From: June Grinstead <june@technicaldrawingsltd.co.uk>
Sent: 12 November 2009 14:25
To: Carlos Hone
Subject: Fwd: A Hart, 3 Norbury Drive, Lancing, BN15 0QN
Attachments: Proposed Elevations 3 Norbury Drive.pdf

JOB:
PROPOSED LOFT CONVERSION

DRAWING TITLE:
ELEVATIONS

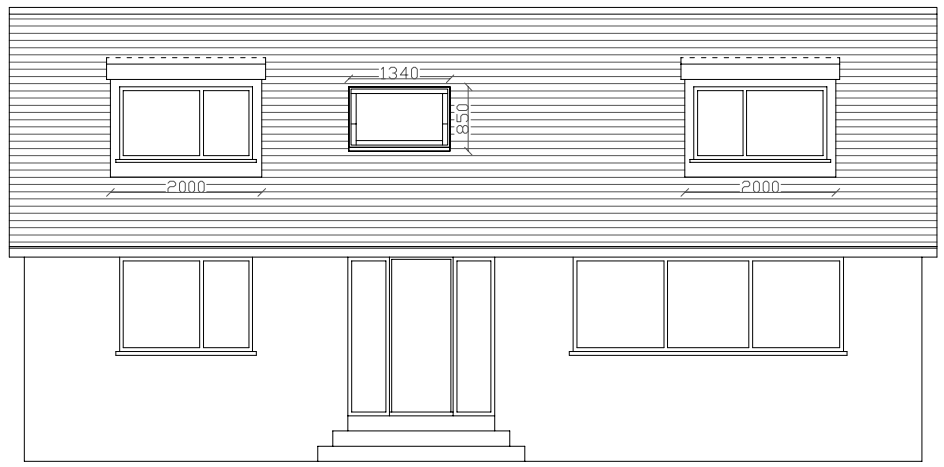
> June,
>
> I will require a full elevation drawing for the front of the dwelling showing how the proposed dormers align with the ground floor fenestration. Additionally the original dormers were far more sympathetic with there being no external tile hanging on the front.You also appear to have reduced the size of the rooflight, please give dimensions and the relationship between it and the front door. The windows in the proposed dormers now do not match the fenestration below as per the approved plans.
>
> I would say that the slight reduction in scale of the dormers would probably be acceptable if they looked like the approved drawings apart from their size.
>
> Please clarify the above points with a revised plan.

Please find attached the full front elevation showing proposed dormers with full width windows and larger Roof Window. Velux do not do 1500mm wide so I have drawn the 1340 x 1400 (showing as 850 long as a sloped roof doesn't show full height).

The alignment between the dormers and velux and the ground floor windows and door are as the Approved Plans.

SIDE ELEVATION

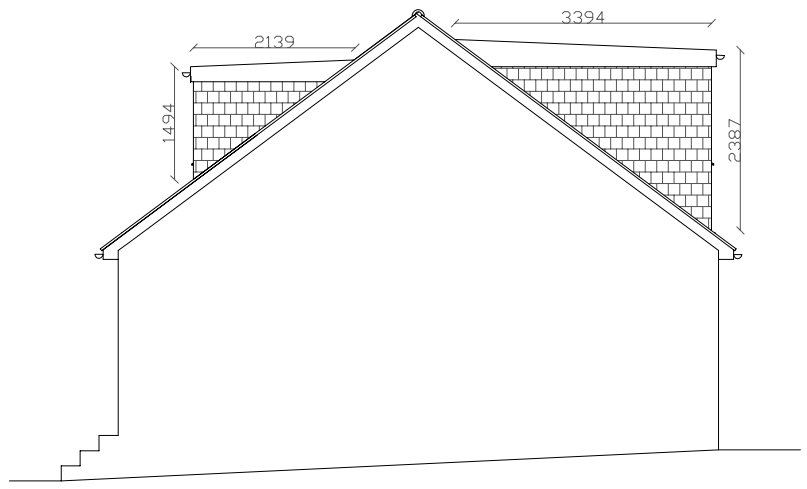
I have looked at the approved plans and can see that the dimensions that you quote on your drawing for the rear dormer are different from those on the approved plans ADC/0317/09. Consequently the proposed (enlarged) rear dormer would now not fall below the 50 cubic metres and requires permission.

On the approved plans each of the front dormer has a volume of 3.73 cubic metres (7.46 cubic metres in total), and when added to the rear dormer the total would be 50.2cubic metres. As it is the dimensions are so tight that I would advise that you leave a leeway of about 5 cubic metres to ensure that the proposals do not require permission, and for any variations that may occur during the construction process. Alternatively if you require a legal determination as to whether planning permission is required you are able to apply for a Lawful Development Certificate under section 191 of the Town and Country Planning Act 1990 (as amended).

Please find attached the elevation plans including front. I have reduced the width of the rear dormer slightly, therefore bringing the total increase to 47.021m. Do you agree that there is enough room for movement to keep within the 50m3 max?
